SANTA BARBARA MONTECITO PLANNING COMMISSION
Staff Report for the Bagdasarian-Karman Appeal of
the P&D Director's Denial of 09LUP-00000-00256

Hearing Date: October 27, 2010
Staff Report Date: October 8, 2010
Case No.: 10APL-00000-00016

1.0 REQUEST

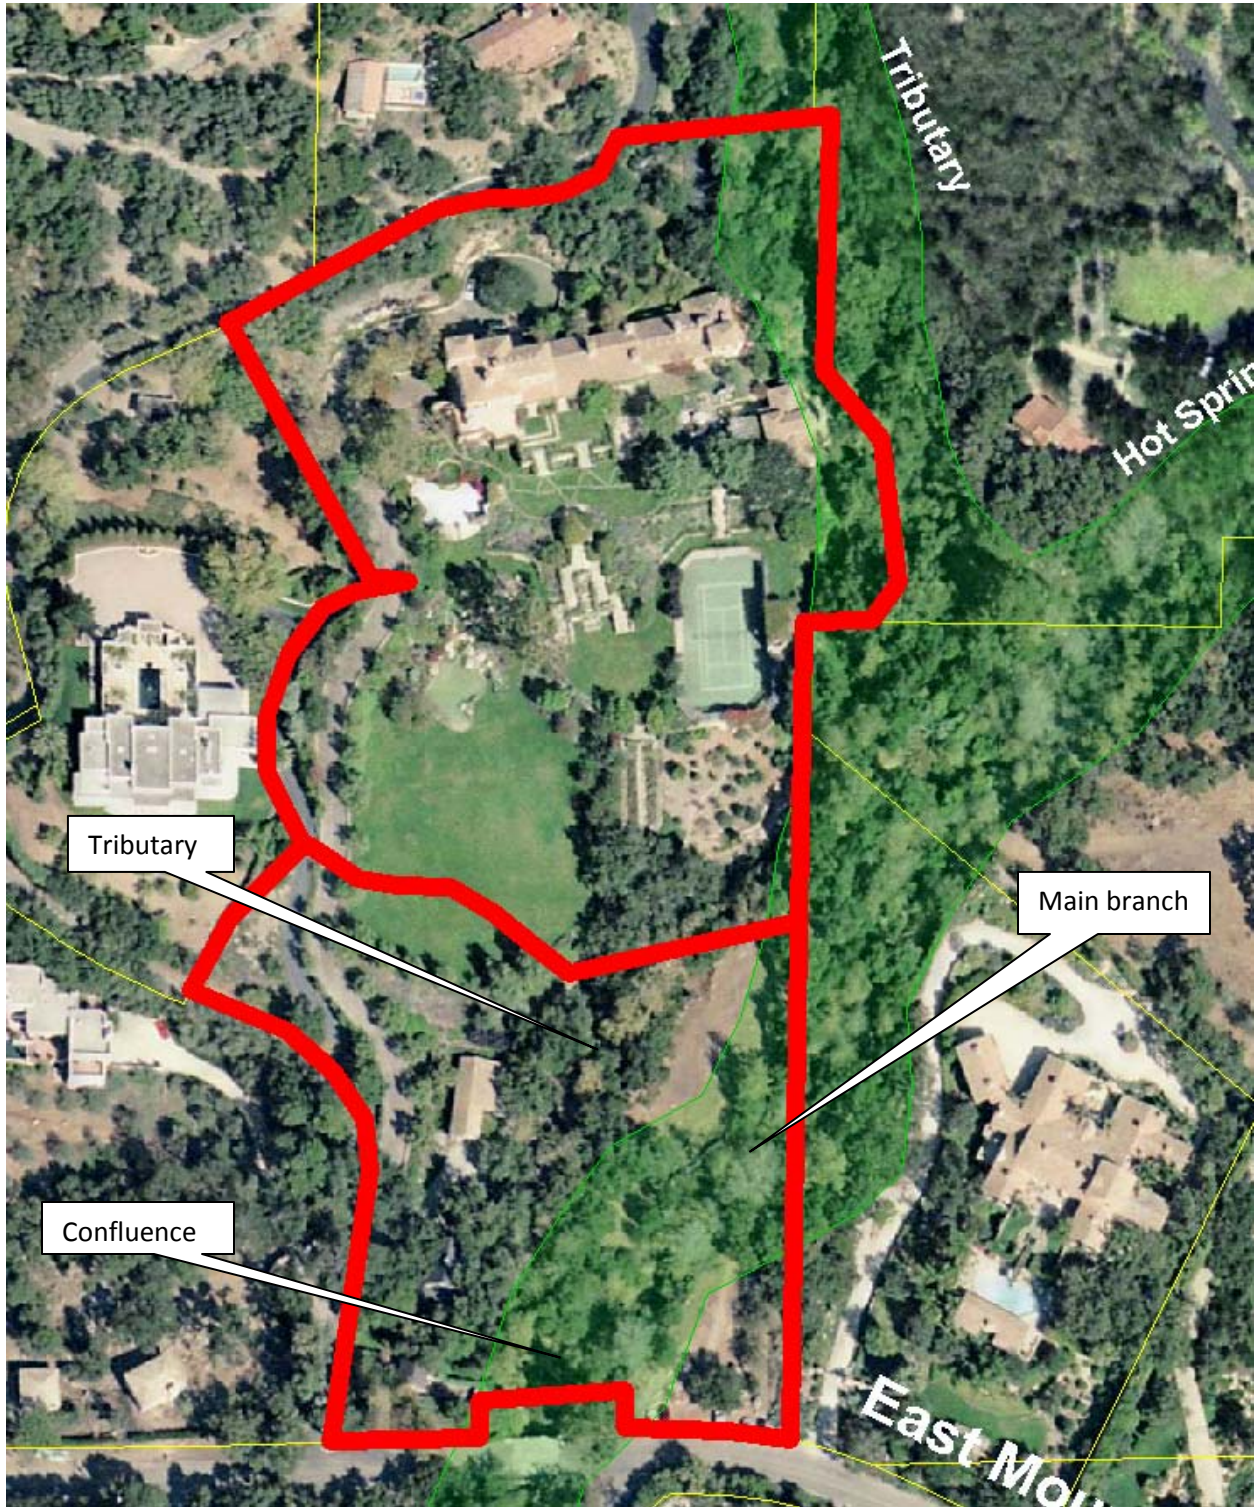
2002 Aerial Photo of Bagdasarian Property with ESH Overlay – Riparian tree canopy coverage over the main branch, tributary and confluence is similar to 1998. This is the first aerial photo for which the mapped ESH Overlay is available, shown by green lines. Note the full tree canopy cover on the adjacent properties to the east.

2004 Aerial Photo of Bagdasarian Property with ESH Overlay – Again, note little to no change to the riparian tree canopy.
